Preliminary Plan Woodlawn Drive Community

Cobb County, Georgia Land Lot 8, 17th District, 2nd Section

PETITION NO: Z-61

ZONING COMMENTS:

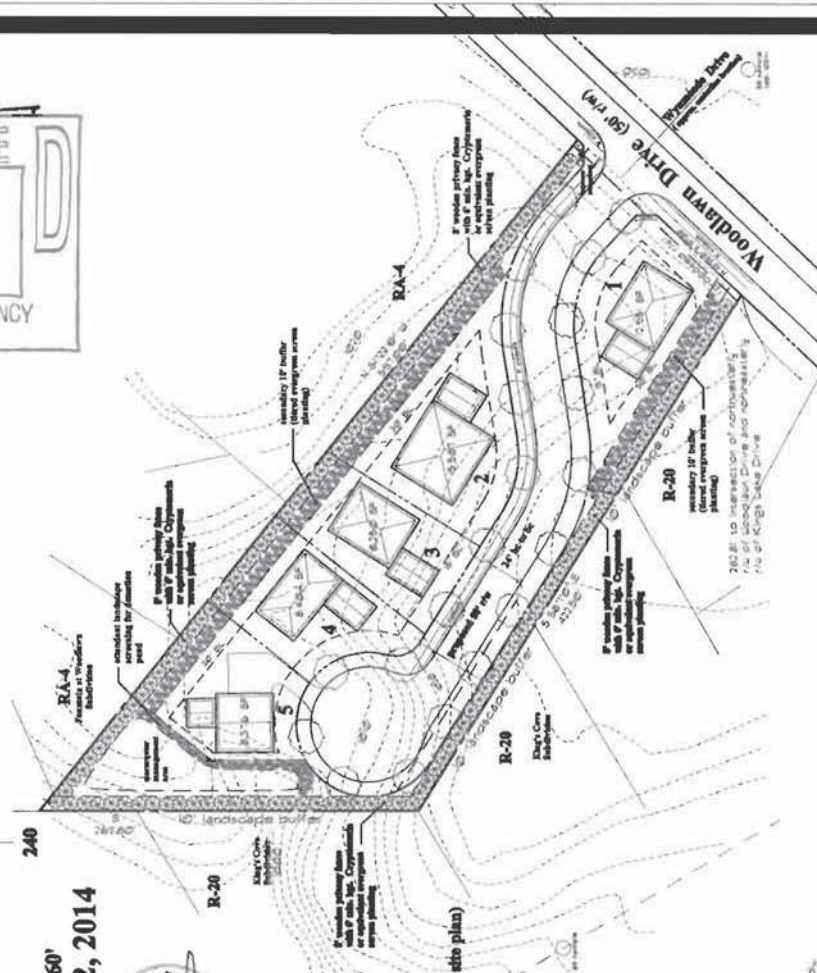
The applicant is requesting a contemporaneous variance to reduce the front setback from 20 feet to 15 feet and also to allow 30-foot rear setbacks instead of the required 40 feet as shown for Lots 2-5 and to allow the setbacks as shown for Lot 1 on the site plan received by the Zoning Division on September 23, 2014.

1. The entire site drains to the northwest into the Kings Cove Subdivision. However, there is no existing drainage easement to convey concentrated discharge from the site. The applicant is working with downstream property owners to obtain an easement to tie into the existing downstream storm system on Kings Lake Drive.
2. As indicated under Downstream Conditions, there is a private lake located approximately 500 feet downstream within the Kings Cove Subdivision. A pre- and post-sediment survey will be required.

Recommend development street either directly align or have an offset of a minimum of 125 feet from Wynmeade Park per Development Standard 401.10.

2. The subject property shall be developed in substantial conformity to that certain revised site plan, prepared by DGM Land Planning Consultants, which is being submitted contemporaneously herewith.

- a. As reflected on the revised site plan, the alignment of the proposed subdivision's entrance with Wynmeade Drive.³
 - b. The voluntary donation and conveyance of right-of-way so that the County can achieve an additional five feet (5') from the subject property's side of Woodlawn Drive.

- a. The ultimate location and configuration of on-site detention, stormwater management and water quality components. As presently shown, the stormwater management area is positioned on the subject property in accordance with recommendations from the Stormwater Management Division. Capital City and subsequently the Mandatory HOA shall be responsible for ensuring that the stormwater management area is treated and/or free of mosquitos.
